**DUBUQUE REGIONAL AIRPORT**  
Terminal Exit Lane Improvements

**END OF ADDENDUM NO. 02**

**DUBUQUE REGIONAL AIRPORT**  
 TERMINAL EXIT LANE IMPROVEMENTS  
 10965 AVIATION DRIVE  
 DUBUQUE, IA 52003

A1.2

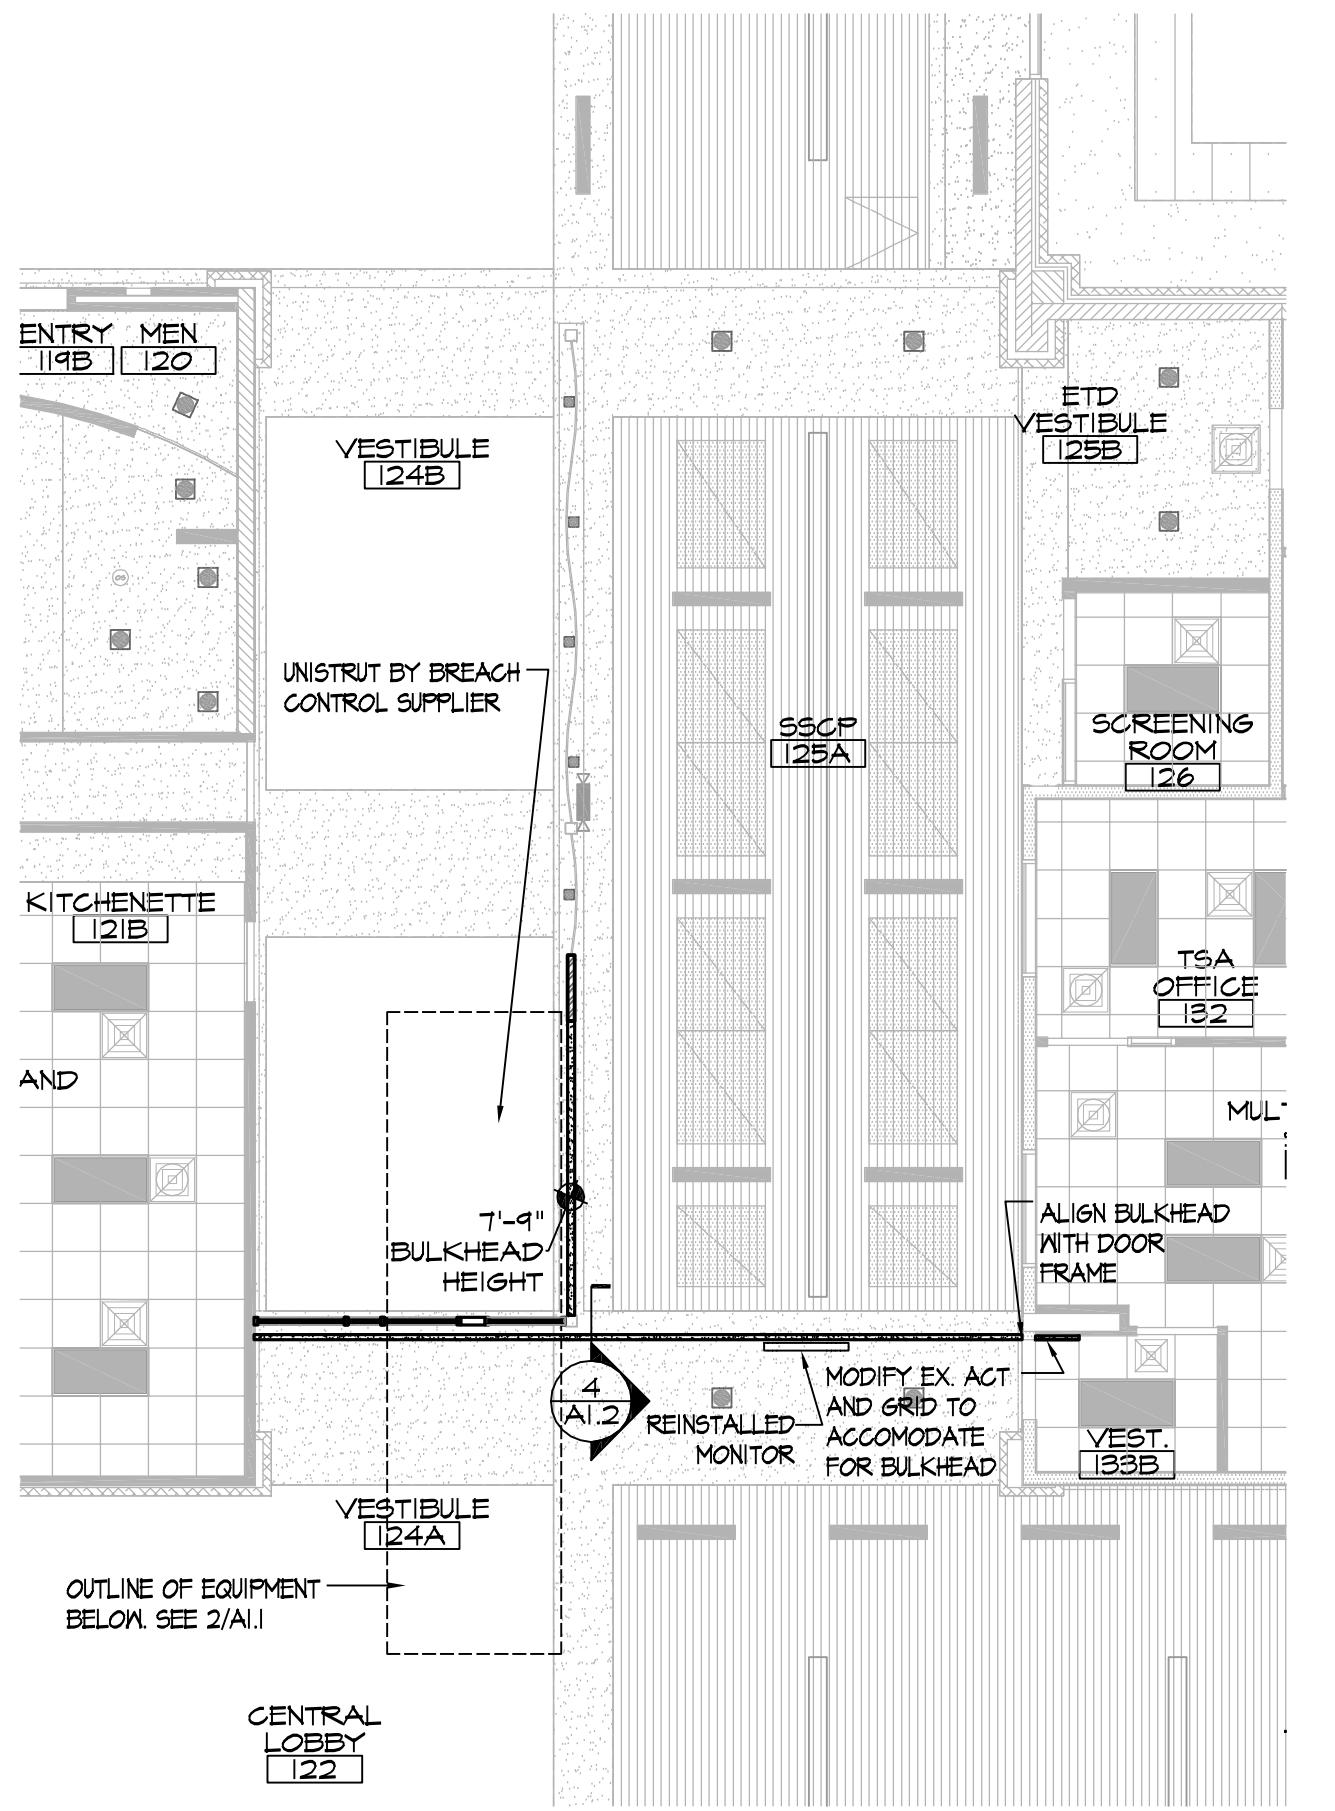
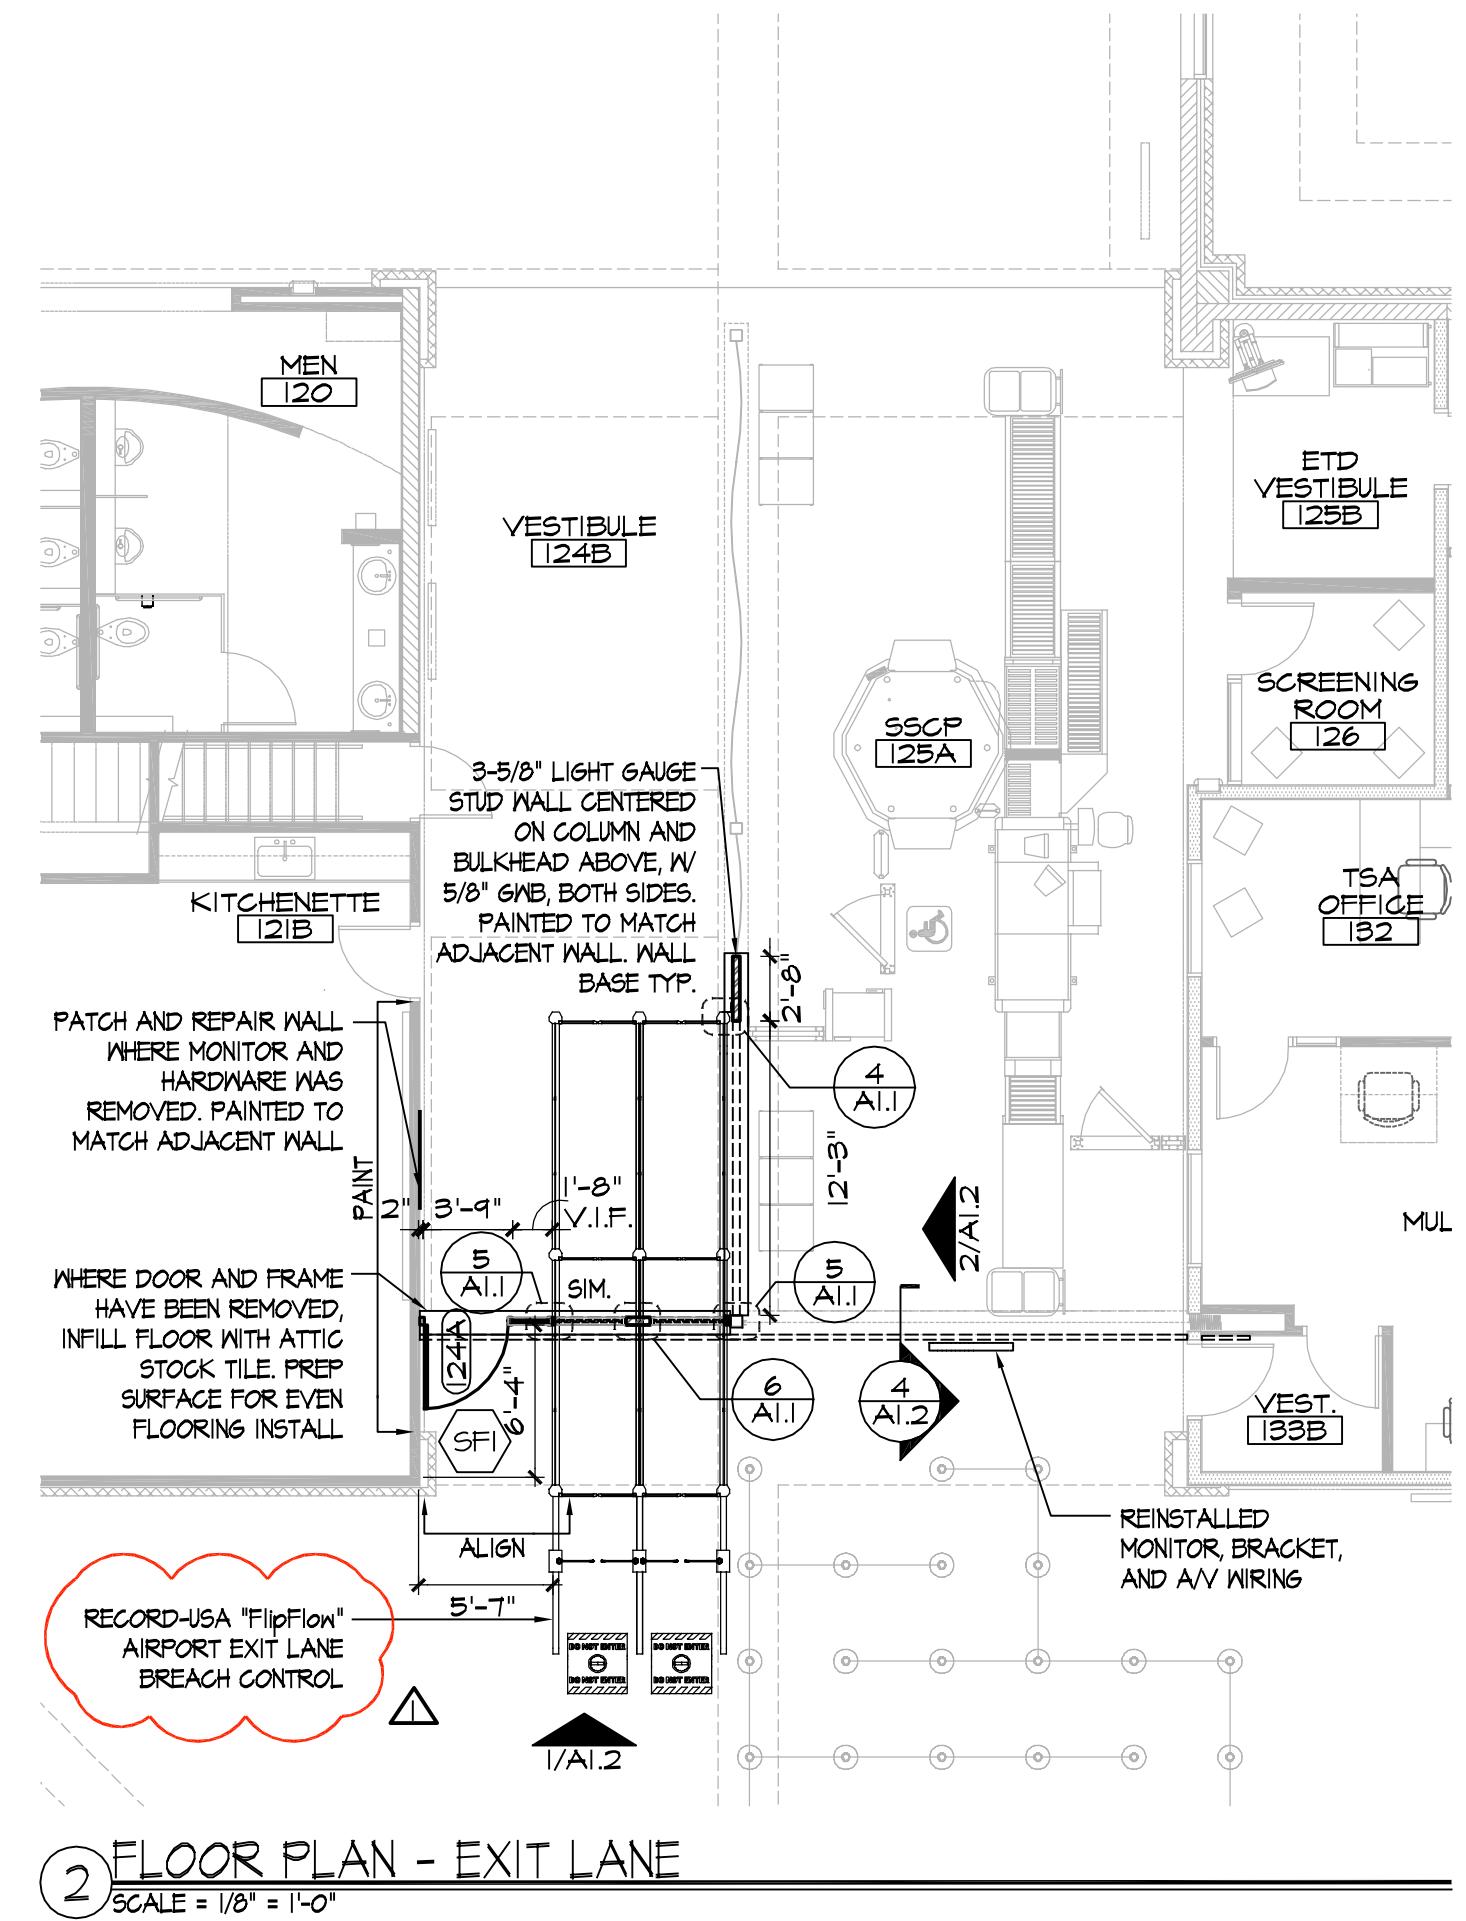
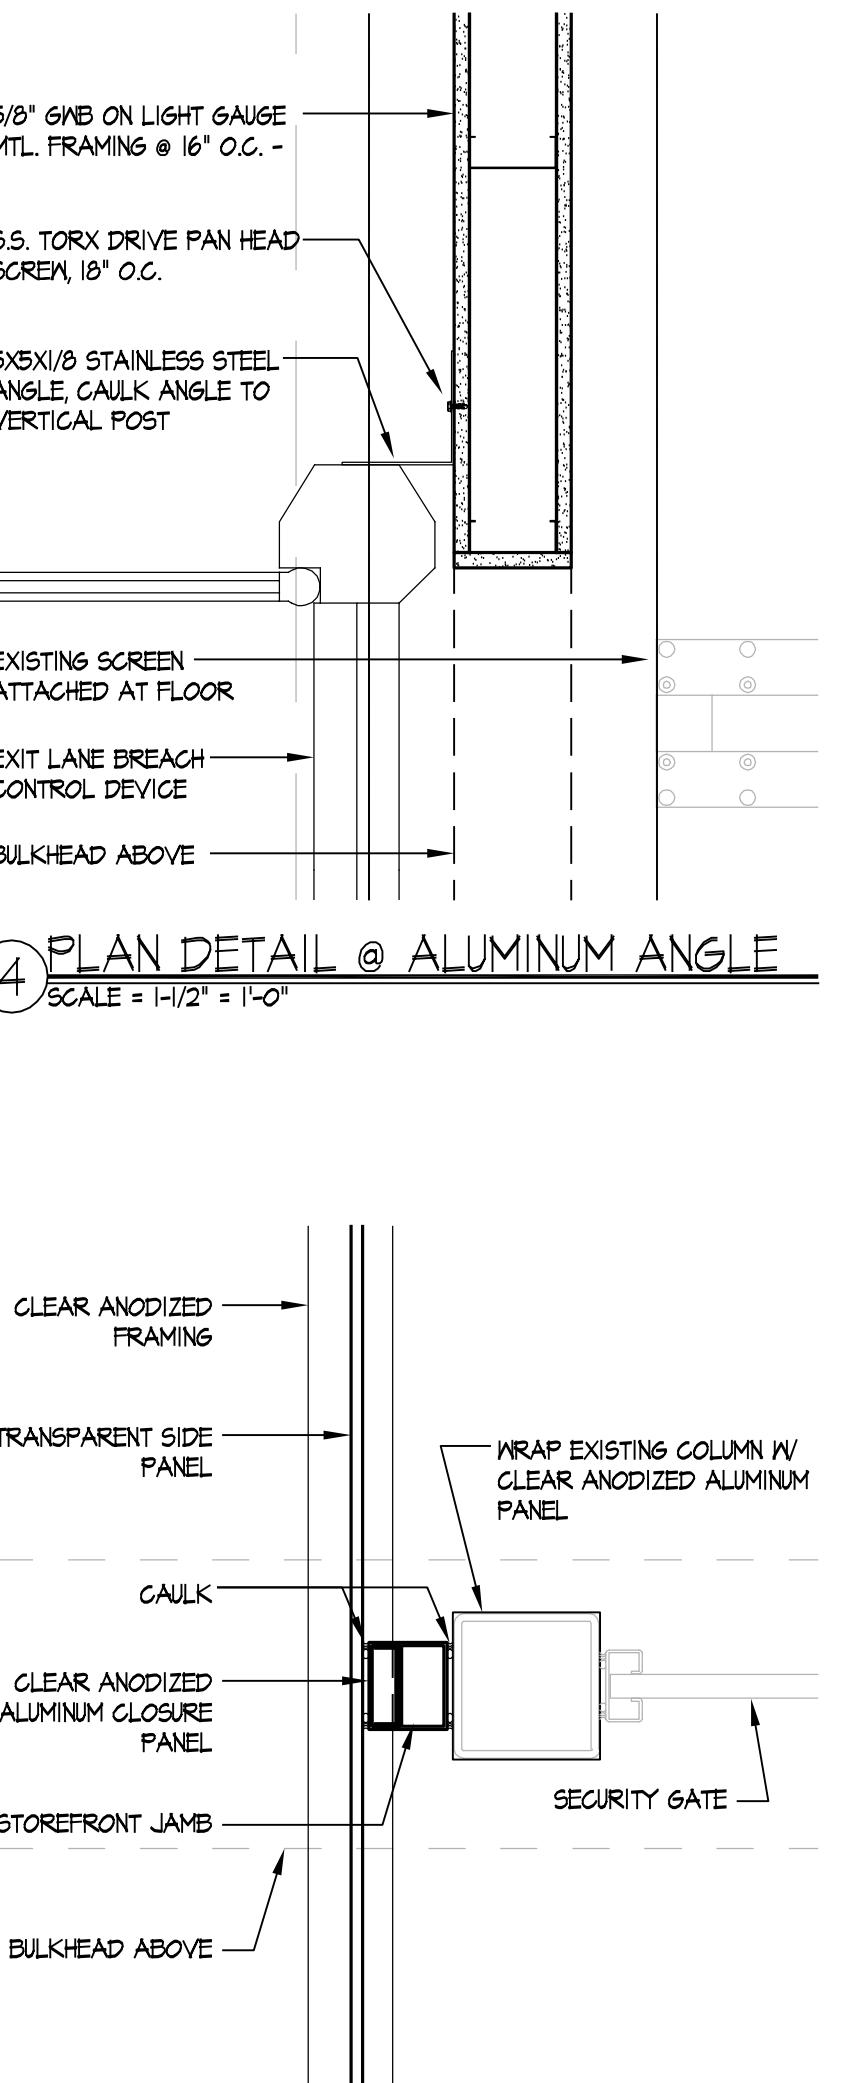
1. Refer to Bid Set:
  - a. **OMIT “By others”** on any note in drawings referencing the Record – USA “FlipFlow” Airport Exit Lane. is included in the specifications and shall be provided by General Contractor and installed as per manufacturer’s requirements.
  - b. Contact Person for Record USA “FlipFlow” is: David Pickers, Vice President of Direct Sales, Record Doors, 704-315-7392 , [david.pickers@recorddoors.com](mailto:david.pickers@recorddoors.com)
